### **Addendum 25: Regulation No. 26**

#### **Amendment 3**

Supplement 1 to the 02 series of amendments - Date of entry into force: 6 July 2000

**UNIFORM PROVISIONS CONCERNING THE APPROVAL OF VEHICLES  
WITH REGARD TO THEIR EXTERNAL PROJECTIONS**

Figure 1 "

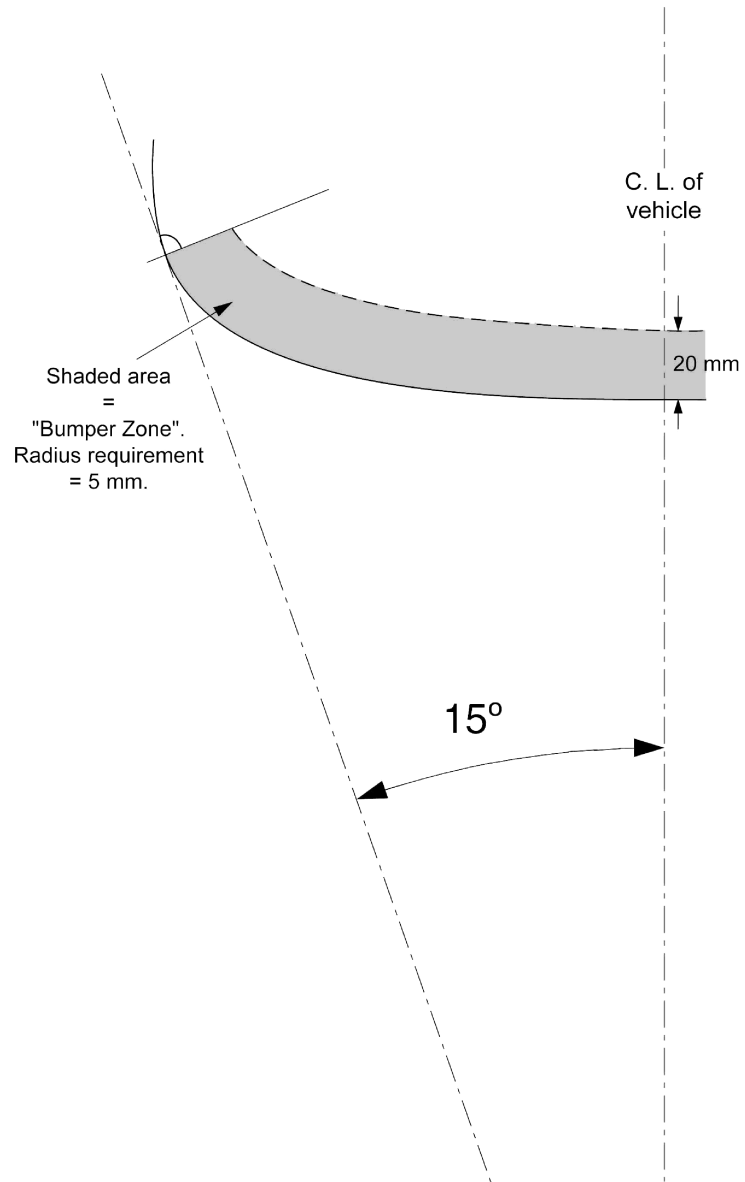
Paragraph 6.5.2., amend to read (including a new figure 1):

"6.5.2. If the line of the bumper which corresponds to the outline contour of the car vertical projection is on a rigid surface, that surface shall have a minimum radius of curvature of 5 mm at all its points lying from the contour line to 20 mm inward, and a minimum radius of curvature of 2.5 mm in all other cases. This provision applies to that part of the zone lying from the contour line to 20 mm inward which is situated between and in front (or rear in case of the rear bumper) of tangential points with the contour line of two vertical planes each forming with the longitudinal plane of symmetry of the vehicle an angle of 15° (see fig. 1).
